SERVICE BULLETIN

ENGINE - FUEL AND CONTROL - TO PROVIDE A NEW ELECTRONIC ENGINE CONTROL (EEC) WITH THE
SCN10B SOFTWARE CONFIGURATION TRIMS - CATEGORY CODE 4 - MOD.ENG-73-0083

V2500-ENG-73-0083

Location of Electronic Engine Control (EEC)
Fig.1

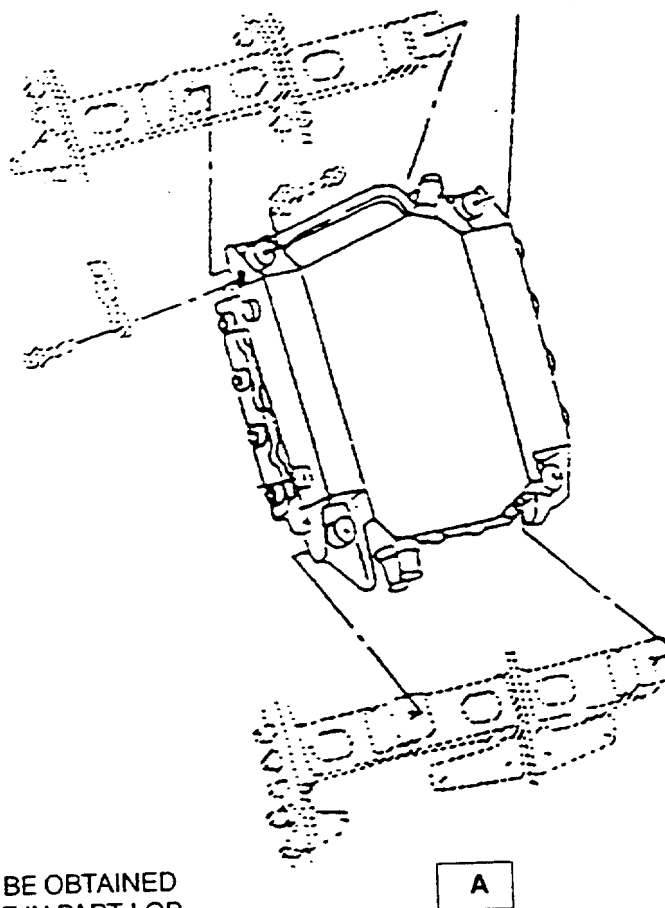
INSTALL THE 808050-4-026
(2A3223) ELECTRONIC ENGINE
CONTROL (1 off)*

*THE NEW CONTROL CAN BE OBTAINED
BY DOING THE PROCEDURE IN PART I OR
PART II OF THIS SERVICE BULLETIN

- (1) Install the 808050-4-026 (2A3223) Electronic Engine Control (1 off) by the approved procedure given in Reference (6), Chapter/Section 73-22-34, Removal/Installation. See Figure 1.
